To: Members of Dublin City Council
From: Marsha I. Grigsby, City Manager *MS*
Date: March 21, 2013
Initiated By: Steve Langworthy, Director of Land Use and Long Range Planning
Re: Ordinance 25-13 – Rezoning – Coffman Reserve (Case 12-066Z/PDP/PP)

12-066Z/PDP/PP
Zoning/Preliminary Development Plan/Preliminary Plat
Coffman Reserve PUD
Coffman Road

**1. Coffman Reserve PUD
12-066Z/PDP/PP** **Coffman Road
Rezoning/Preliminary Development Plan
Preliminary Plat**

**PRELIMINARY PLAT
TREE PRESERVATION PLAN**

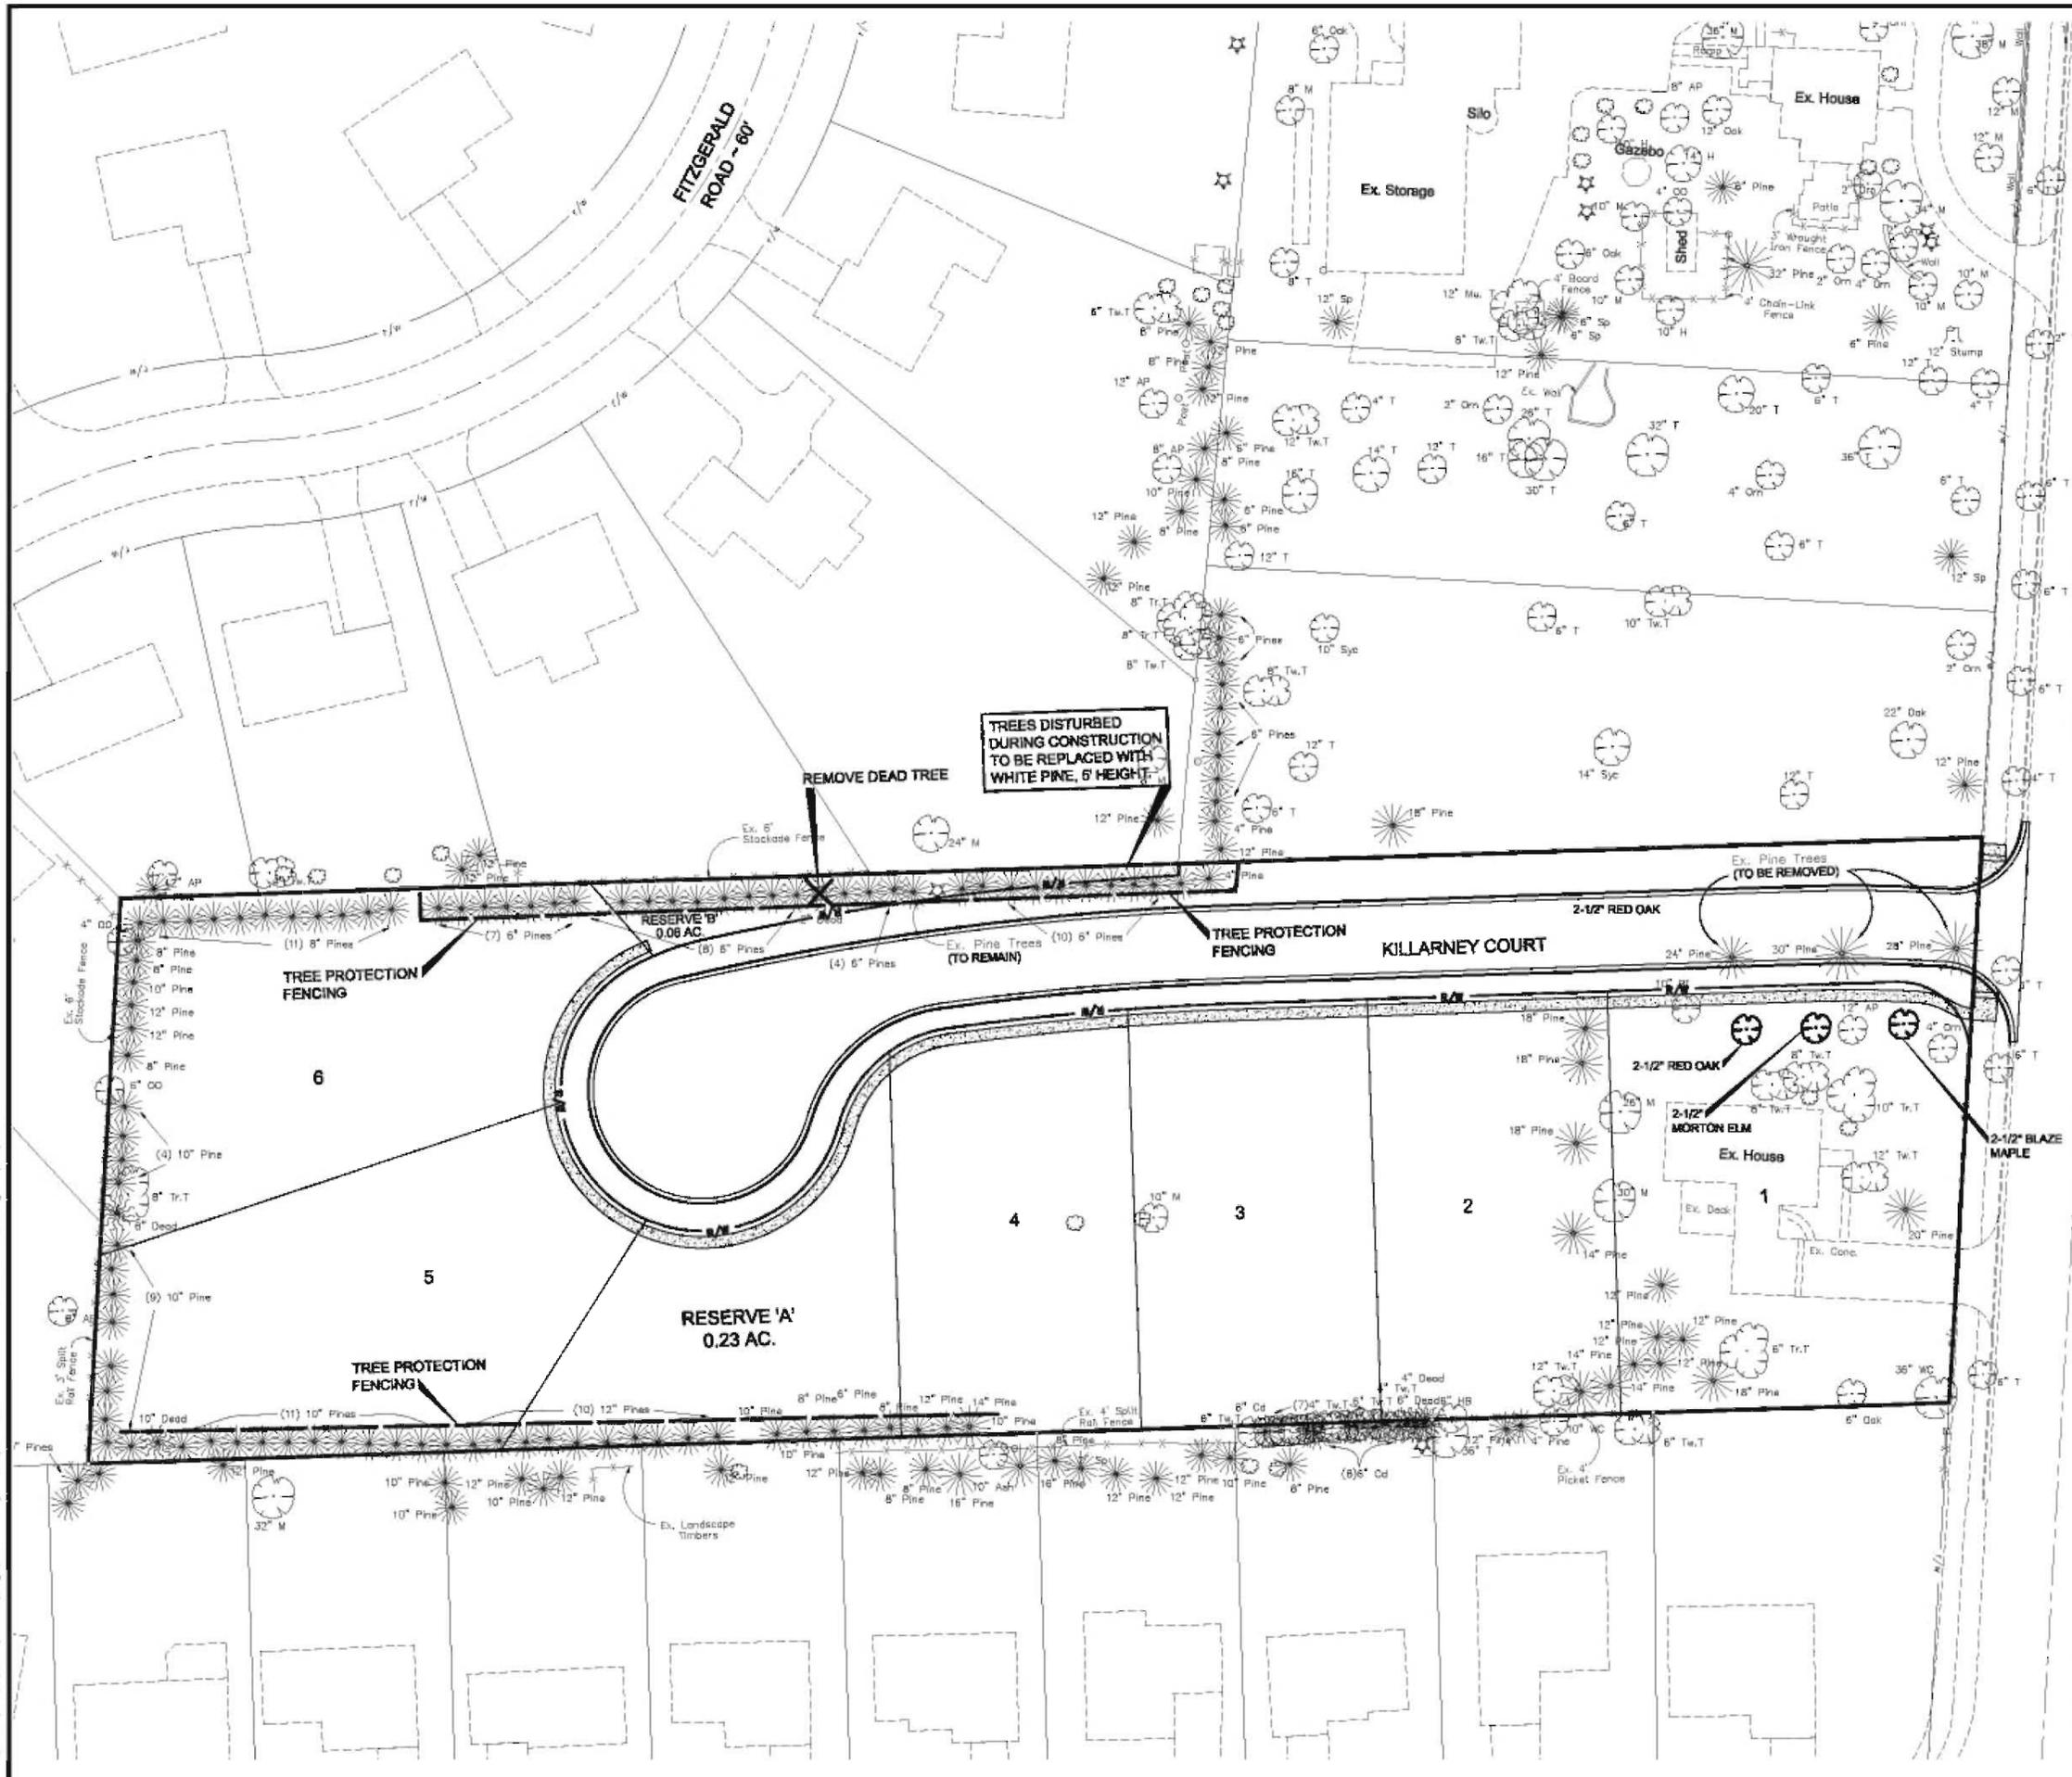
The preliminary tree preservation plan shows 121 trees measuring 6 to 24 inches and four trees of 24 inches and above, all in good condition. No removal information is shown at this time. However, a note on the plan states that disturbed trees north of the proposed road will be replaced with white pines, which are not permitted to be counted as replacement trees. The applicant has made efforts to maximize tree preservation with this proposal by locating the road as much to the south of the tree line as possible and including the area in a reserve for tree preservation.
